4-6-17  
Received  
Jolene Wolfley

Amend the IDO to maintain this policy:

**IDO Zoning**

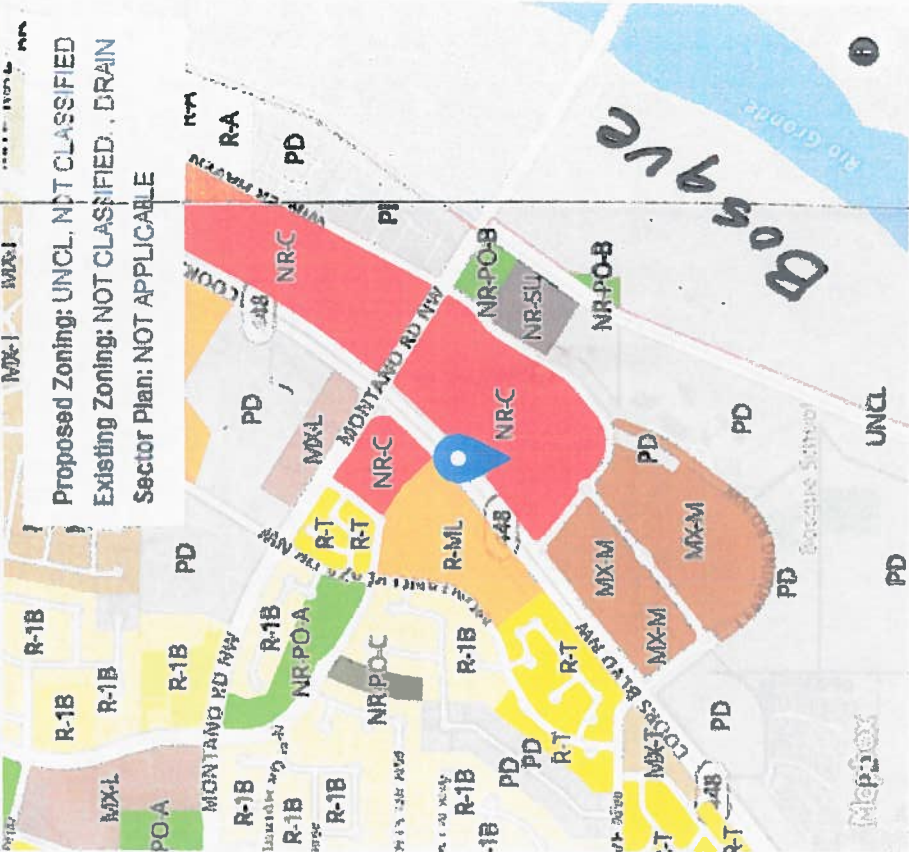
Likely Admin Site Plan Review

- EPC Site Plan Review

**Likely Admin site Plan Review**

**- EPC site Plan Review**
